**SB-10046959-1169**

SI B18 06 12  
Exhaust Systems

**Voluntary Emissions Recall Campaign 11E-A03: Replace the SCR Mixer**

E70 and E90 with the M57Y engine

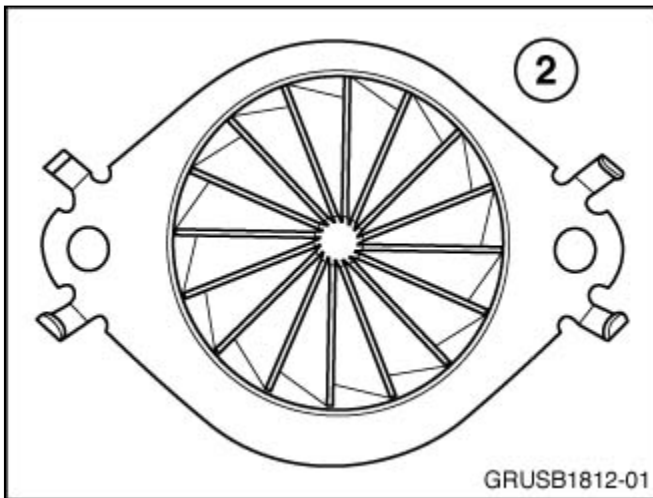
The original style mixer has a multiple fin arrangement (1).

The updated mixer has one set of fins (2).

Replace the mixer (Repair instruction 18 31 140).

This mixer will need to be replaced with P/N 18 30 8 513 445 (E70) or P/N 18 30 8 512 438 (E90).
